LiDAR Quality Assessment Report

SD_Missouri River Lidar Dewberry_2016_D16 - Block3

NGTOC
2018-06-12
Sarah Klaas

Project: SD_Missouri River Lidar Dewberry_2016_D16 - Block3

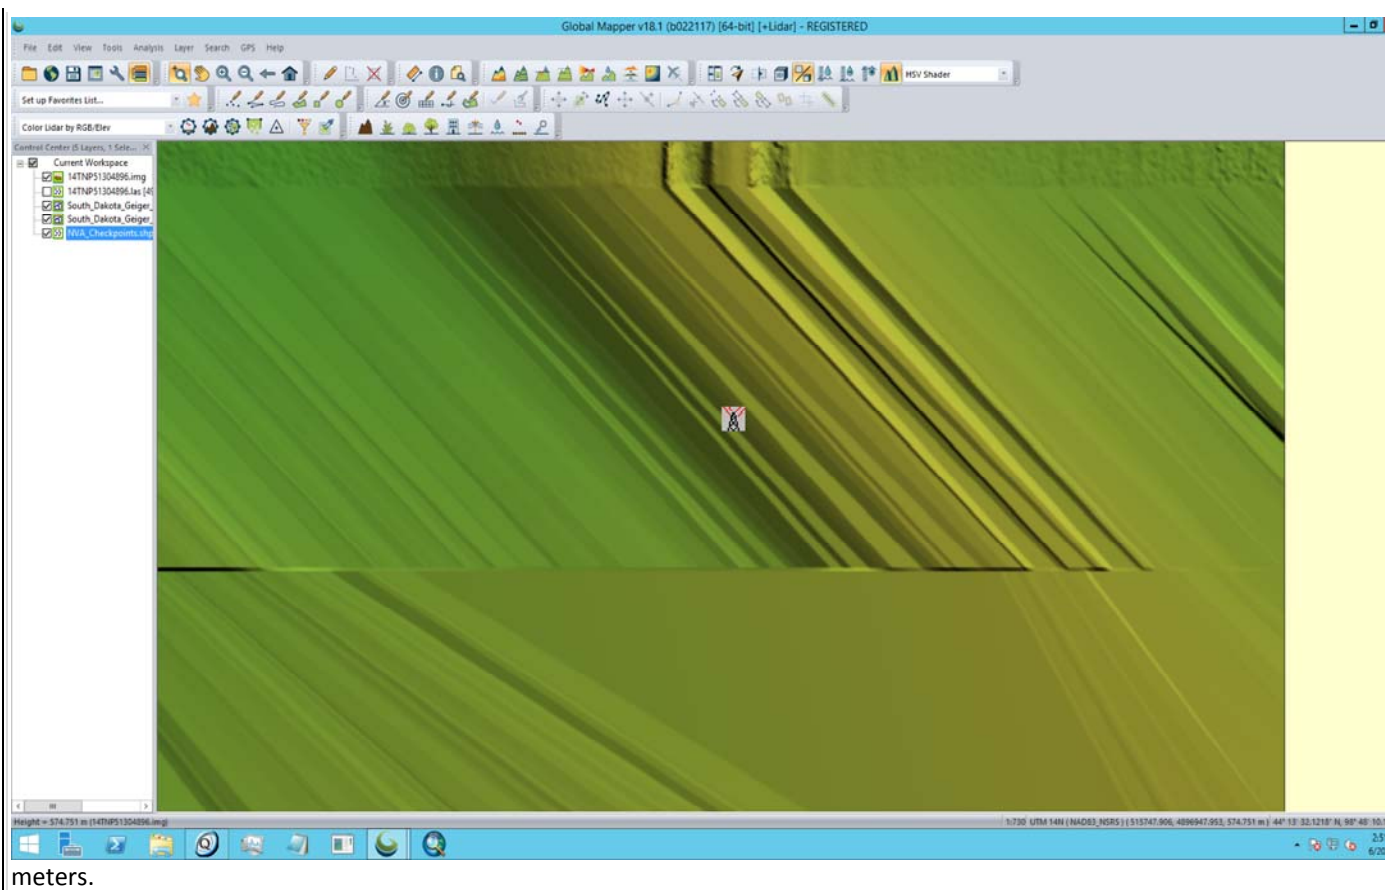
VVA testing failed to meet USGS specifications. Three of the worst points are pictured below, showing the checkpoint below the ground surface.

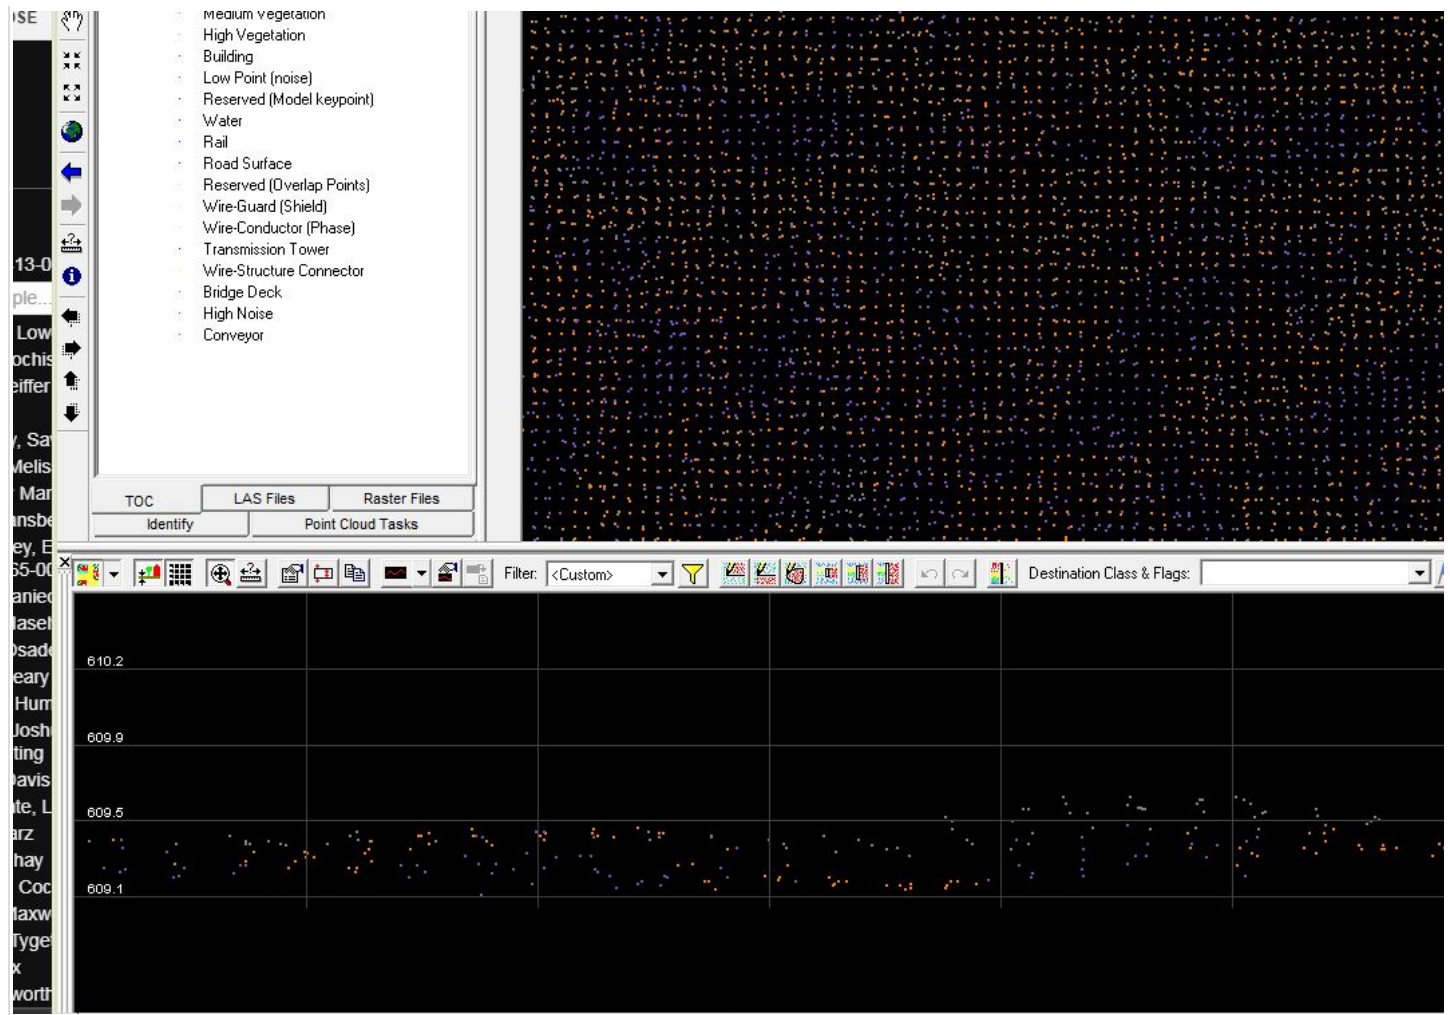
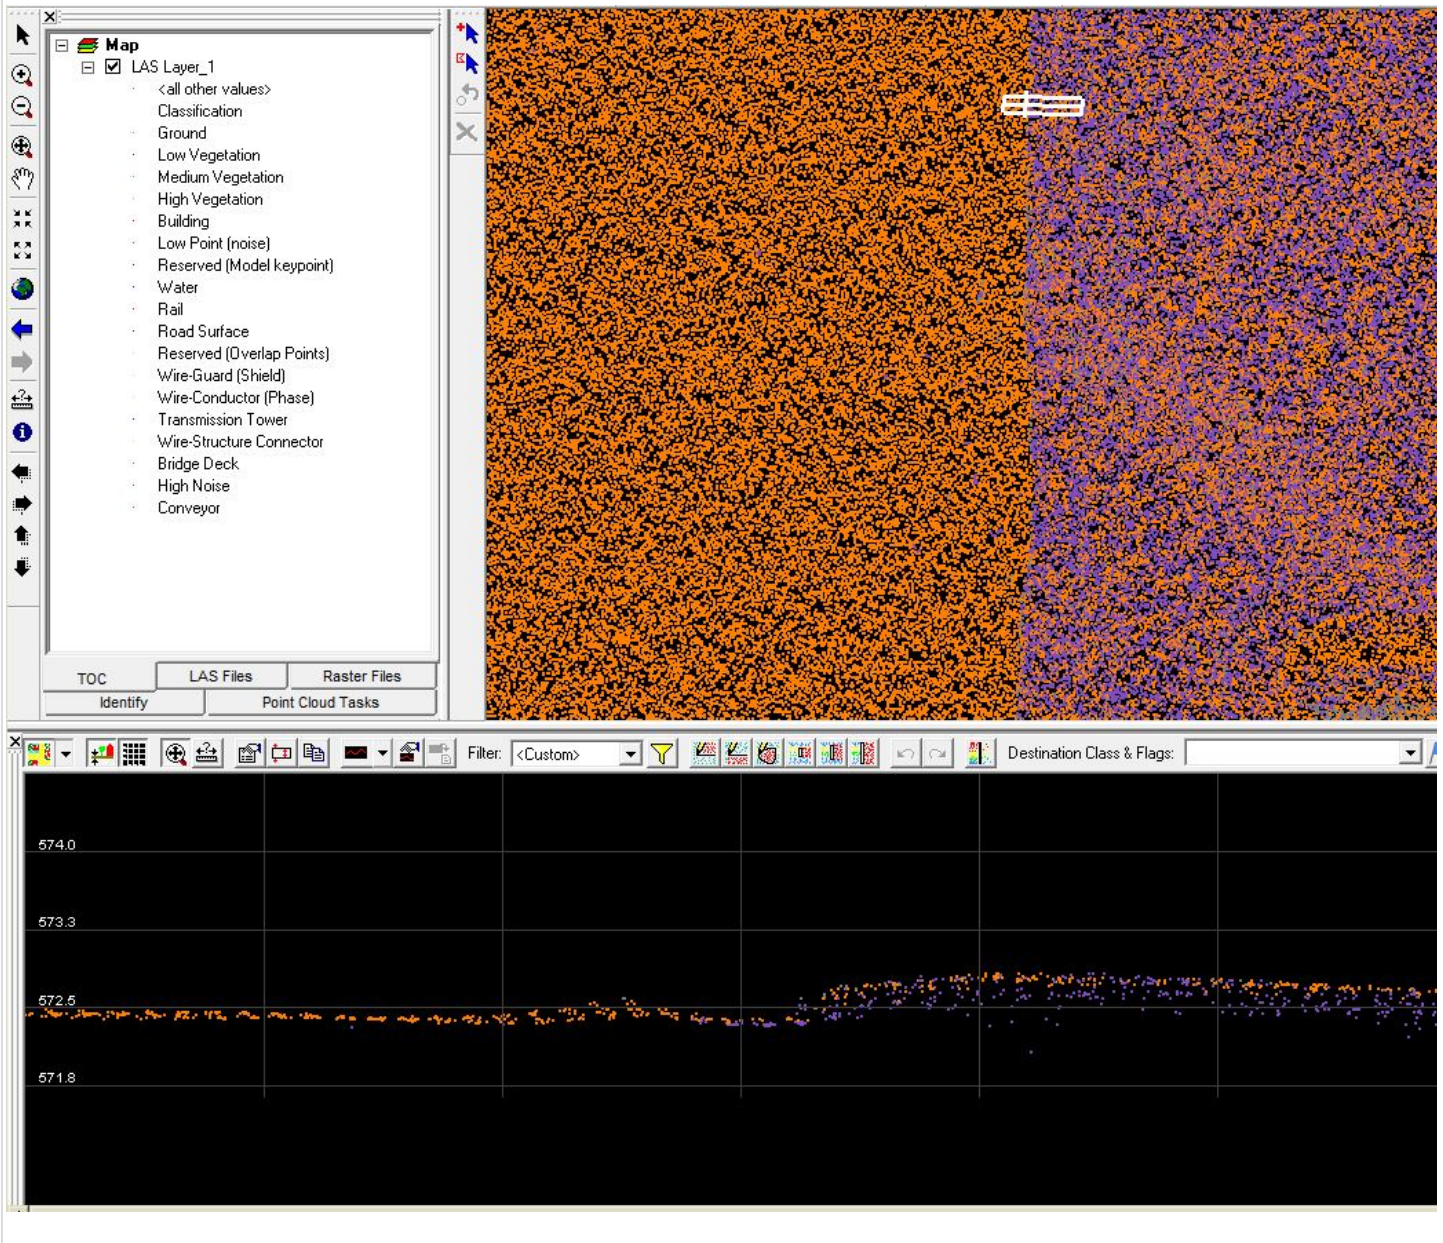
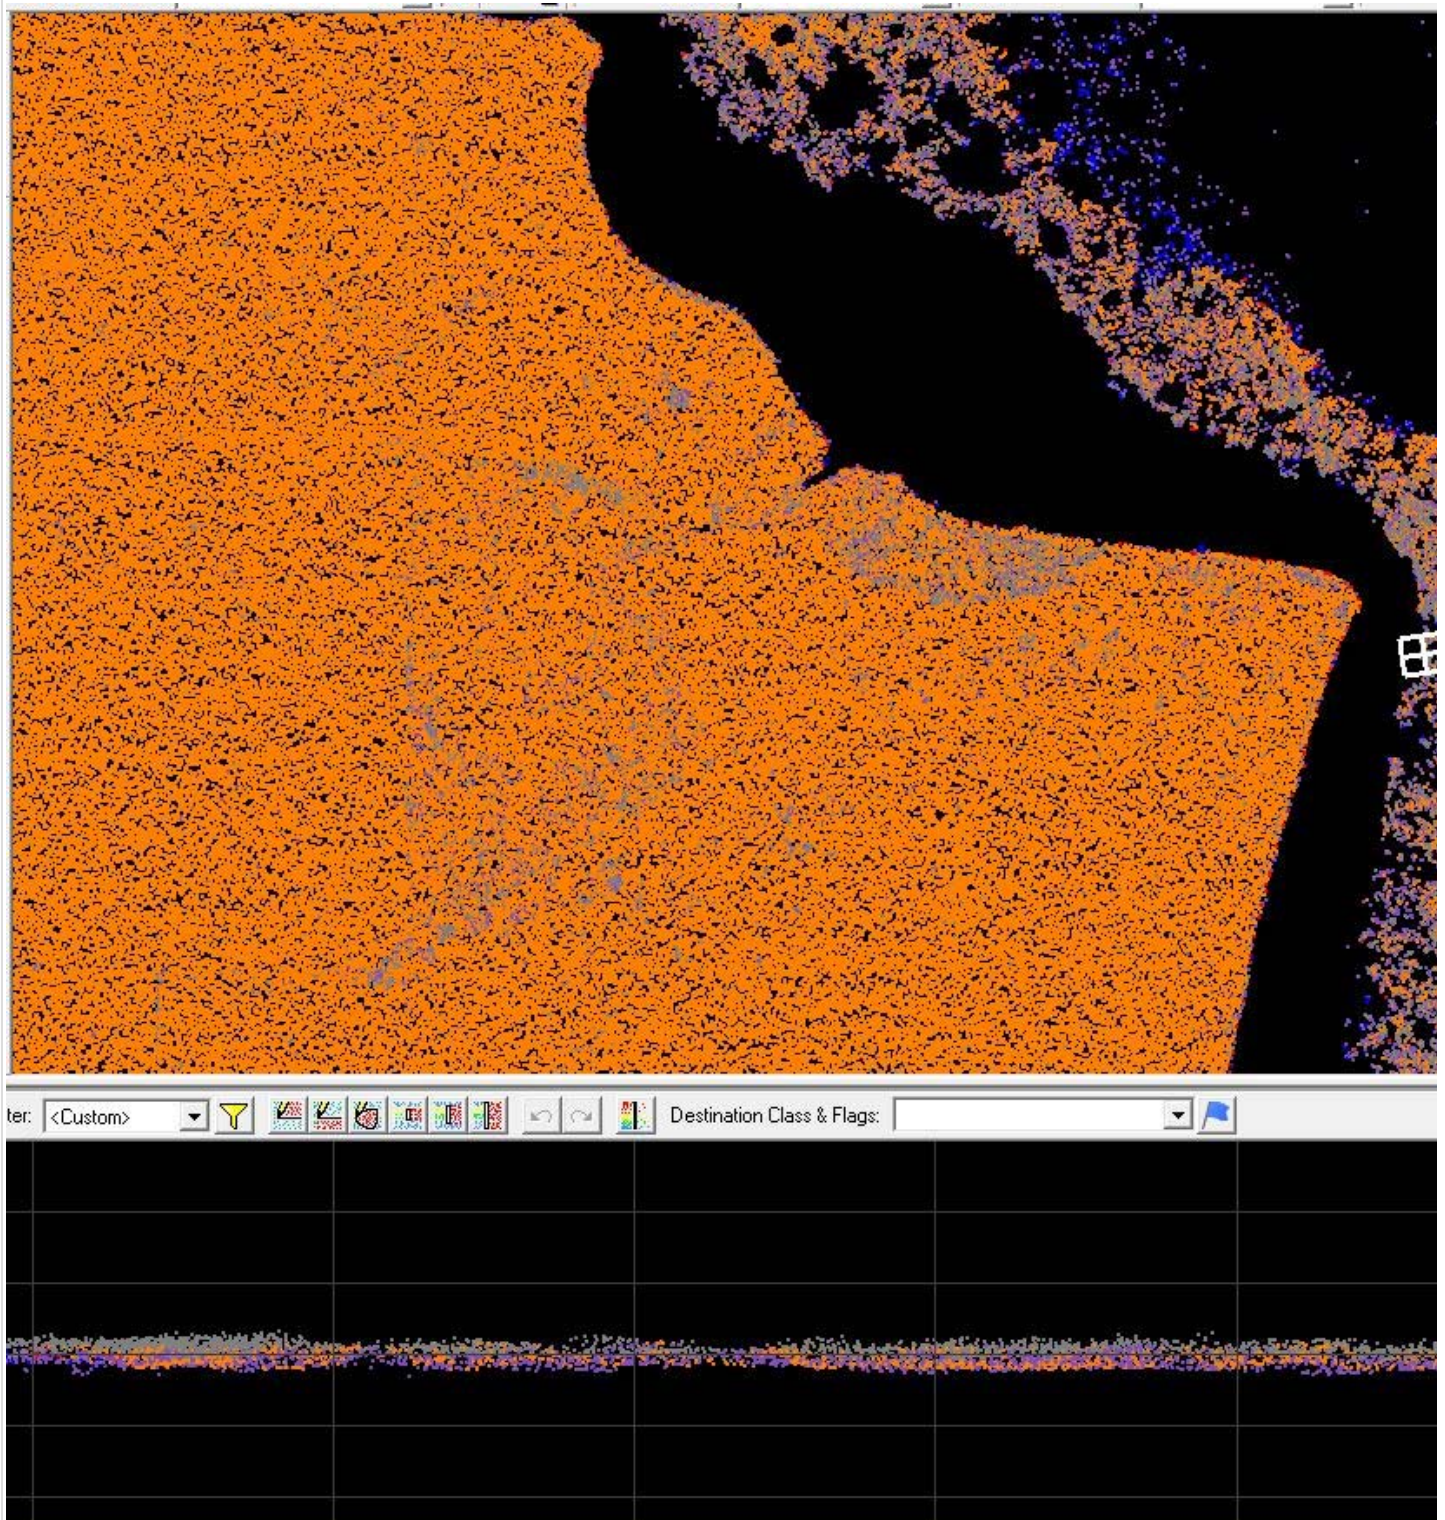
Examples of possible classification issues: ground noise points interchange in the first picture which brings to question which is the true ground surface?

Picture two showing area of dense noise in relation to ground points.

Picture three is showing a large lake with ground points within the lake body, possible algae?

Not Corrected (9/20/2018)

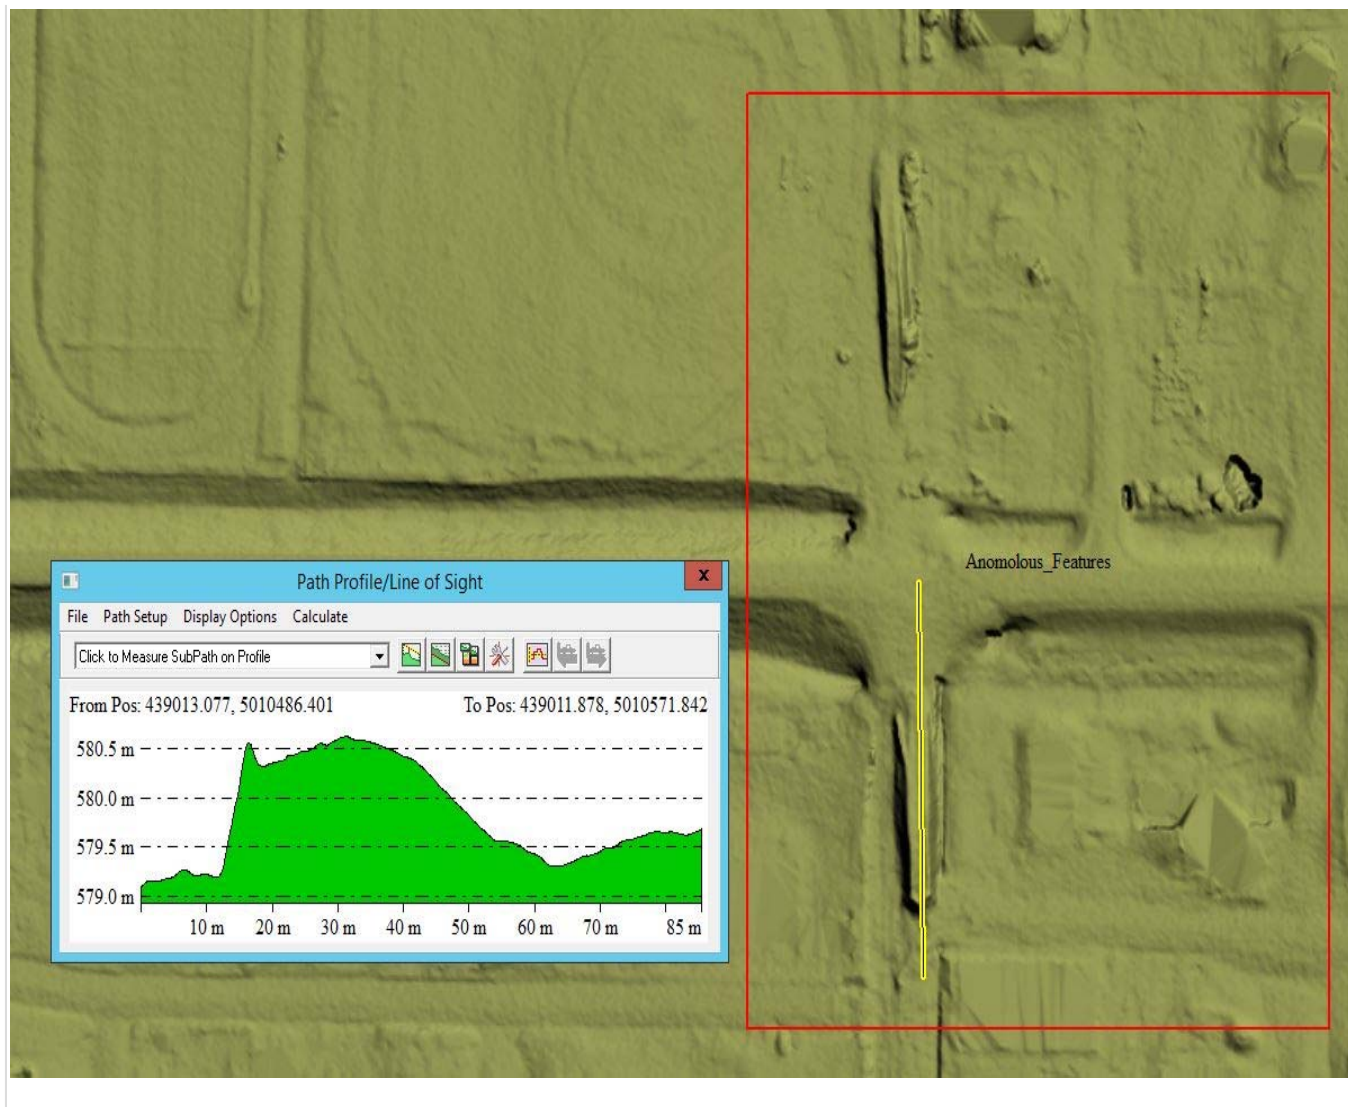
4 anomalous errors probably related to the geiger mode sensor were found. (6/11/2018)

Street in a small town looks like it's been scraped off also there is a pit in the roadway in two places

Ramp features and pits that are not on the actual surface of the earth as far as can be seen in imagery.

Corrected (9/18/2018)
